Town of Amherst
Zoning Board of Appeals
Town Hall, 4 Boltwood Ave.
Amherst, MA 01002

We are abutters to the property at 134 Cowls Road in North Amherst, and are writing regarding the North Square permit application and related zoning matters. We listed below relevant zoning bylaw provisions and conditions that we feel would help address our concerns as abutters, which were outlined in our more general letter of 1/2/17.

Figure 1 – noise complaints, downloaded from http://maps.amherstma.opendata.arcgis.com/datasets/87ea9519a8ba43518855b860a495613f O.geojson. The numbers indicate the number of noise complaints at the given location, with dates from 2014 through 2016.

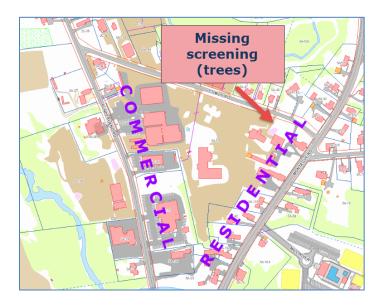
Given likely high student occupancy, noise will be a nuisance to neighbors, based on noise complaints from similar developments as show in the map in figure 1 below.

Figure 2 – Commercial / residential boundary missing screening as required by 10.392.

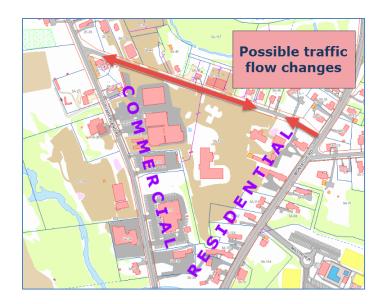
There do not seem to be any attempts at screening the development on the north eastern side or mitigating noise. See the note on 10.392 below for more on this.

The proposed development, and current usage, establish an unbroken commercial zone from Montague Road all the way west to Sunderland Road along the south side of Cowls Rd. This substantially undermines the residential character of the residentially zoned portion of Montague Rd north of the Mill River.

Requiring screening tree plantings between Atkins and the residential portion of 134 Montague as shown in Figure 2 would help address the issues related to 10.392 above. It would also help mitigate noise and lighting related to 10.393 and 10.385. Tall, dense trees along this strip would dramatically reduce the effects of noise, light pollution, and general residential versus commercial landscape characteristics.
